Bulletin No.: Pl0876

Service Bulletin

Subject: Transmission Fluid Level Indicator Handle Broken

Models: 2007-2013 Cadillac Escalade Models

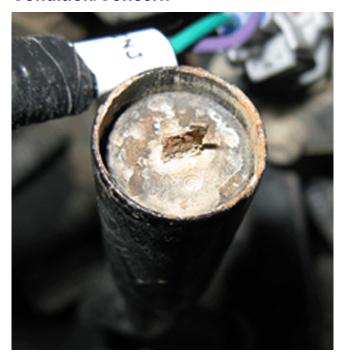
Some customers may comment that while attempting to remove the transmission fluid level indicator to check the fluid, the handle breaks off. Further investigation reveals that the metal indicator material was corroded and broke where the plastic handle is attached.

Technicians should replace the transmission fluid level indicator with the updated part number. The new part is darker in color as shown below.

Part Number	Description
24267668	INDICATOR, TRANS FLUID LVL
